CALL NO. 101  
CONTRACT ID NO. 111313  
ADDENDUM # 1

Subject: Jefferson County, HPP 0163 (032)  
Letting April 22, 2011

**The Parklands of Floyds Fork - Project 2A**  
 Backley Creek Park - North  
 Louisville, Kentucky

MODIFICATIONS TO CONTRACT DOCUMENTS:

**C-7001**

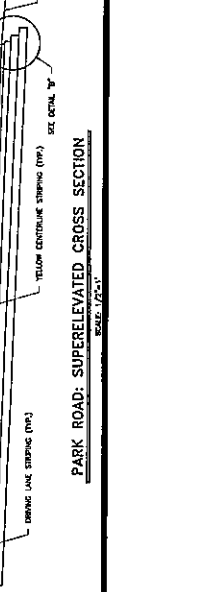
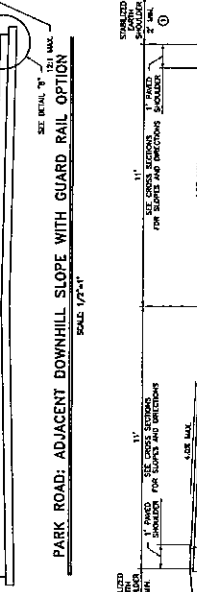
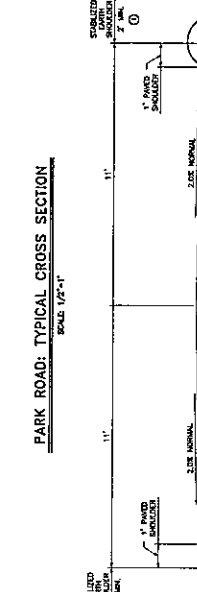
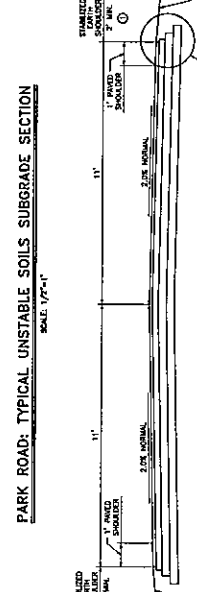
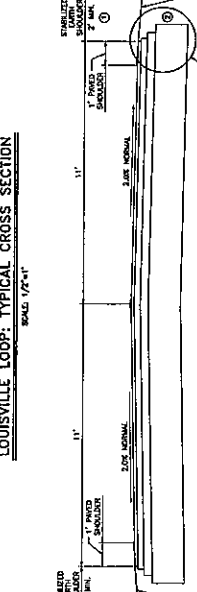
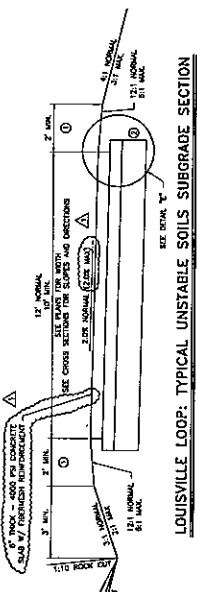
<u>Sheet #</u>	<u>Description</u>
C-7001	Typical Sections <u>LOUISVILLE LOOP: TYPICAL UNSTABLE SOILS SUBGRADE SECTION</u> and <u>LOUISVILLE LOOP: TYPICAL SECTION</u> : Change “(5.0% MAX)” slope to “(2.0% MAX)”. Also add note “6” THICK – 4000 PSI CONCRETE SLAB 2/ FIBERMESH REINFORCEMENT”.
C-7002	Typical Section <u>LOUISVILLE LOOP: TYPICAL CROSS SECTION STA. 37+50+ TO STA. 73+00±</u> : Change “(5.0% MAX)” slope to “(2.0% MAX)”.
SP-1001	Added column with values for Approximate Tip of Pile Elevation in Pile Record table.
SP-2001	Added column with values for Approximate Tip of Pile Elevation in Pile Record table.

**WALL 1  
LAYOUT &  
DETAILS**  
Drawing No:  
**SW-1001**

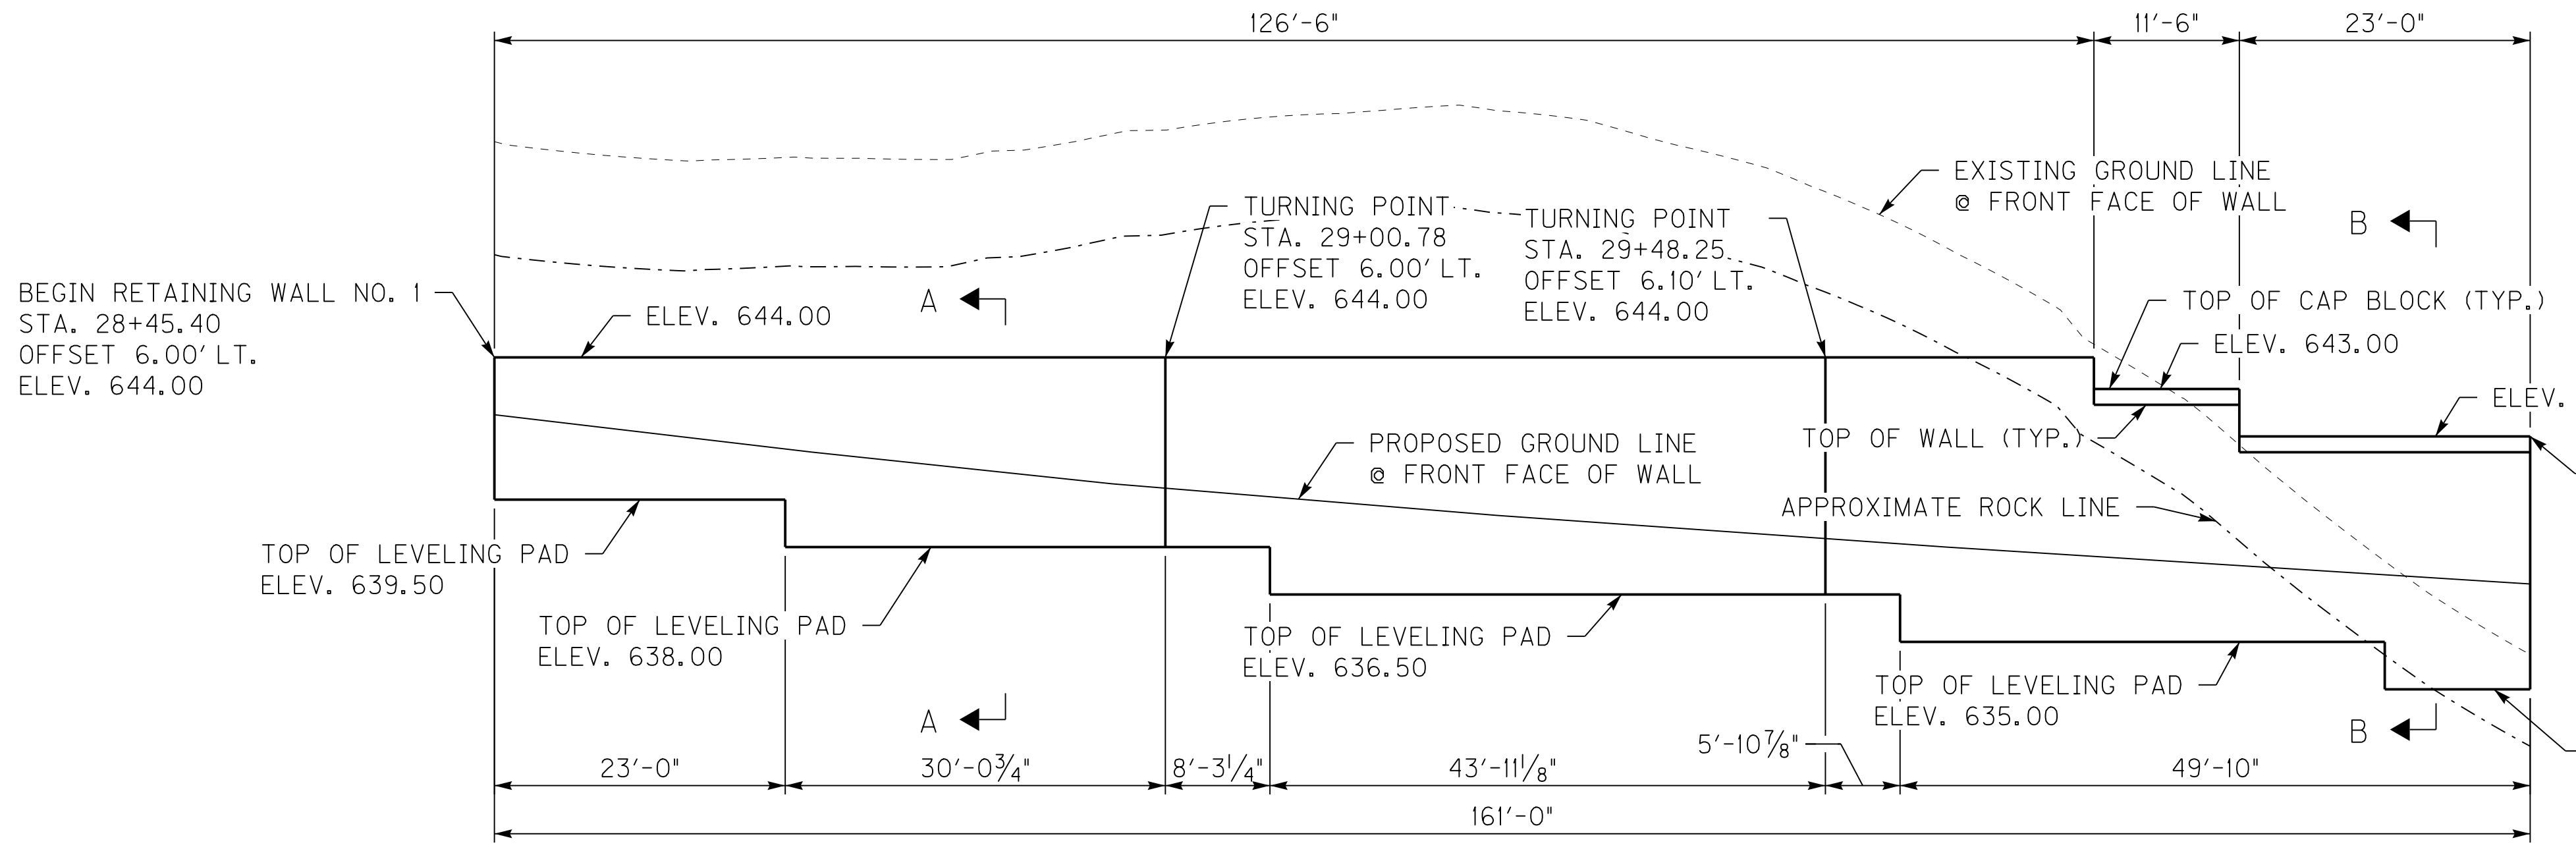
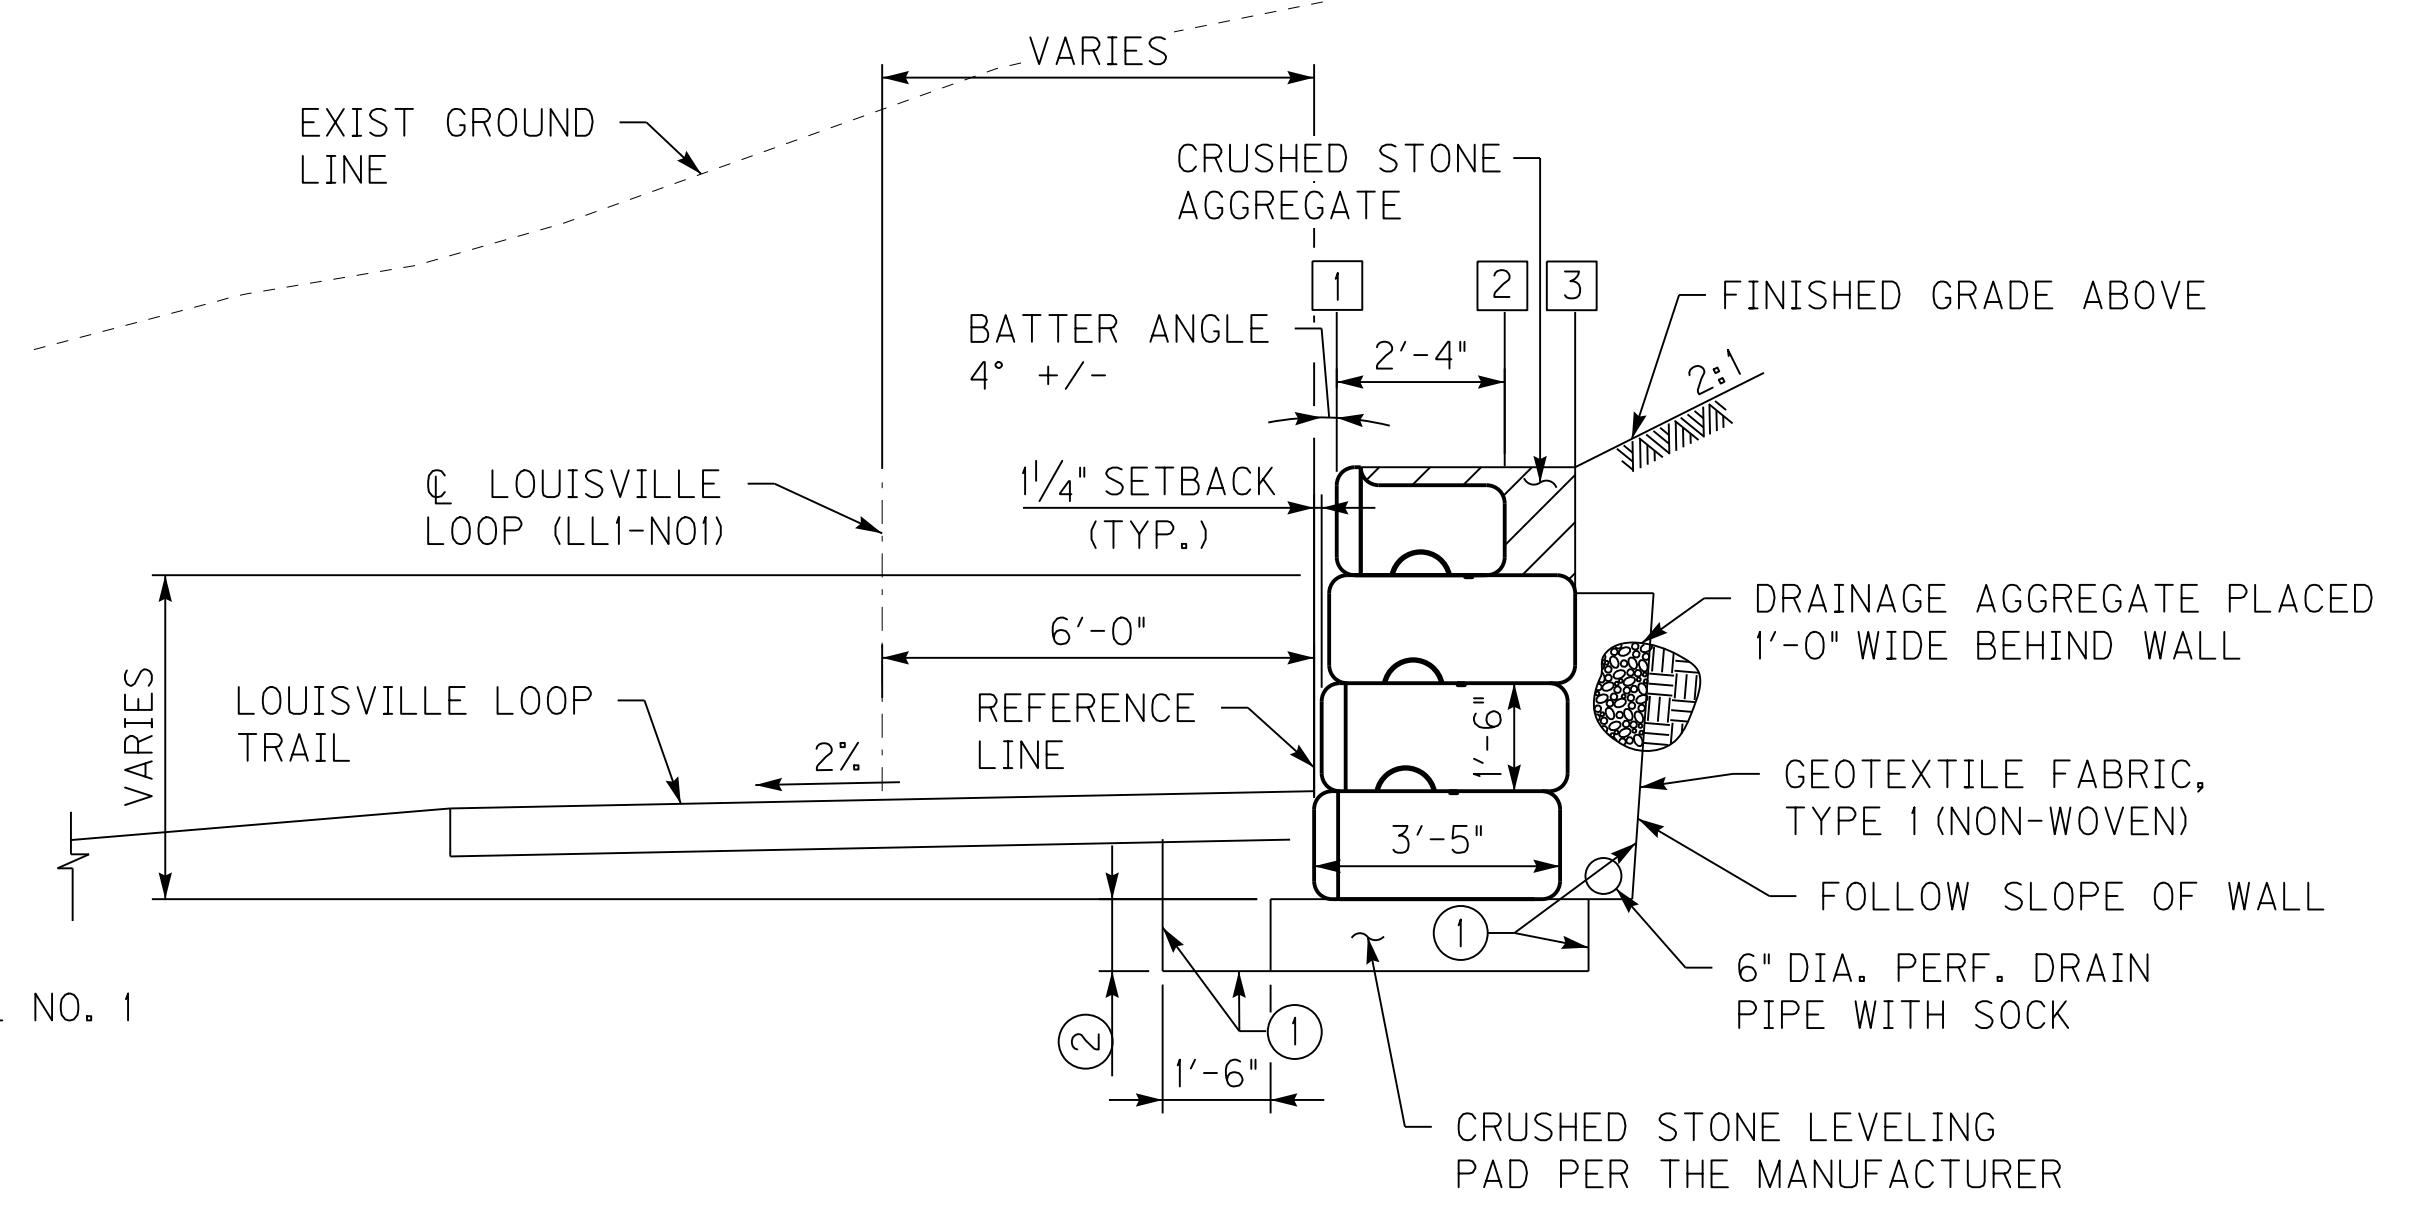
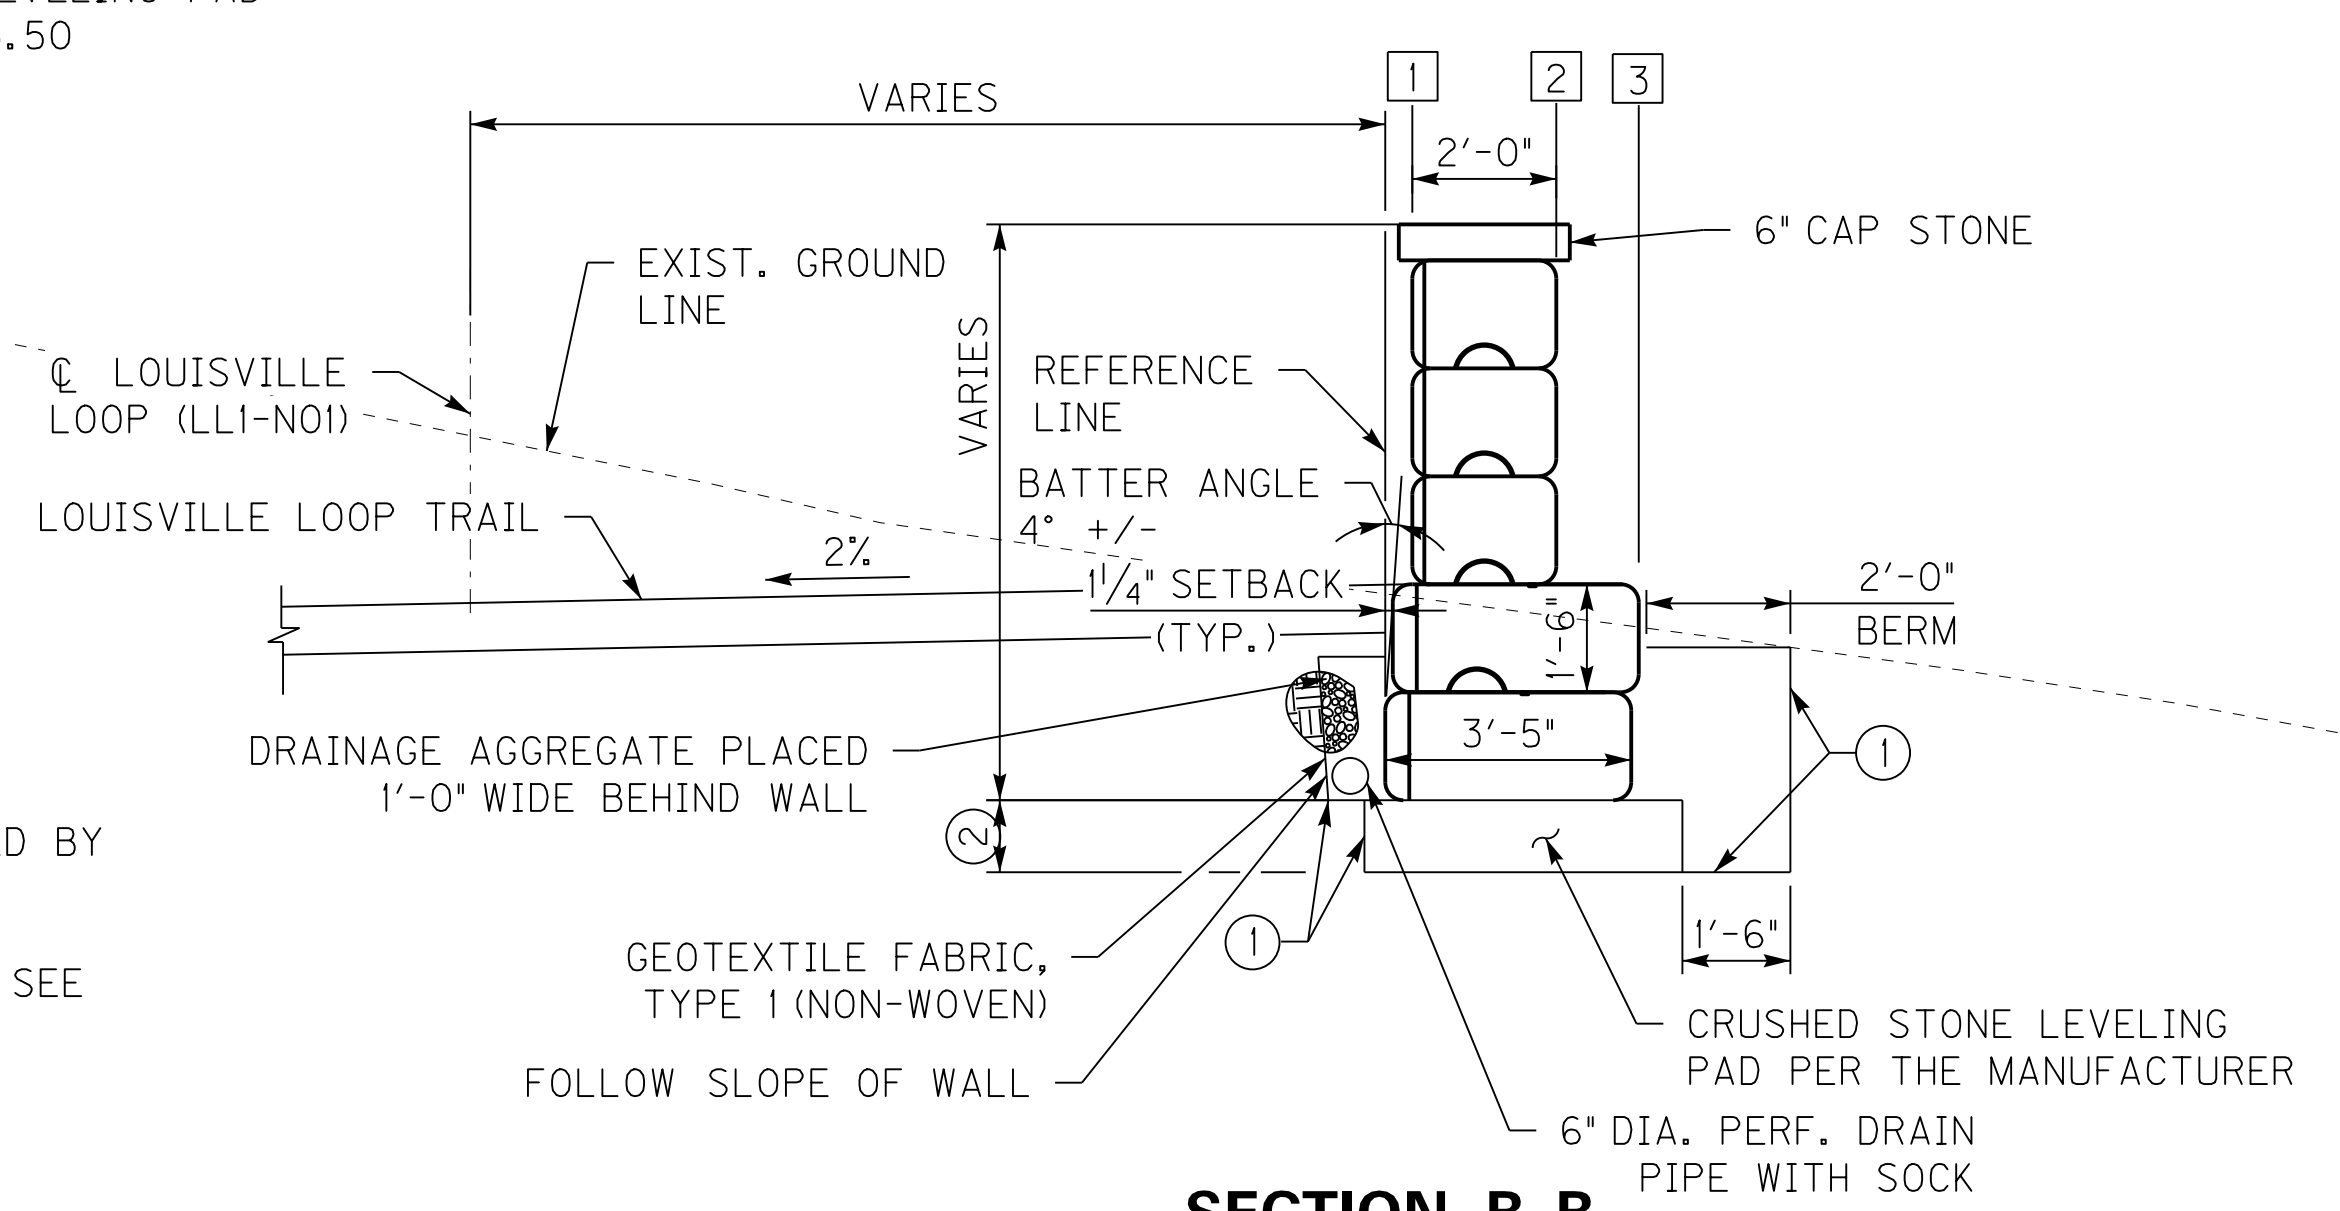
- SW-1001 Revised note to read “The wall block system shall be the Ledgestone series with color scheme “Kentuckiana Buff” as manufactured by Redi-Rock of Kentuckiana, Mt. Washington, KY., or approved equal.
- SW-2001 Revised note to read “The wall block system shall be the Ledgestone series with color scheme “Kentuckiana Buff” as manufactured by Redi-Rock of Kentuckiana, Mt. Washington, KY., or approved equal.
- SW-3001 Revised note to read “The wall block system shall be the Ledgestone series with color scheme “Kentuckiana Buff” as manufactured by Redi-Rock of Kentuckiana, Mt. Washington, KY., or approved equal.
- SW-6001 Revised note to read “The wall block system shall be the Ledgestone series with color scheme “Kentuckiana Buff” as manufactured by Redi-Rock of Kentuckiana, Mt. Washington, KY., or approved equal.
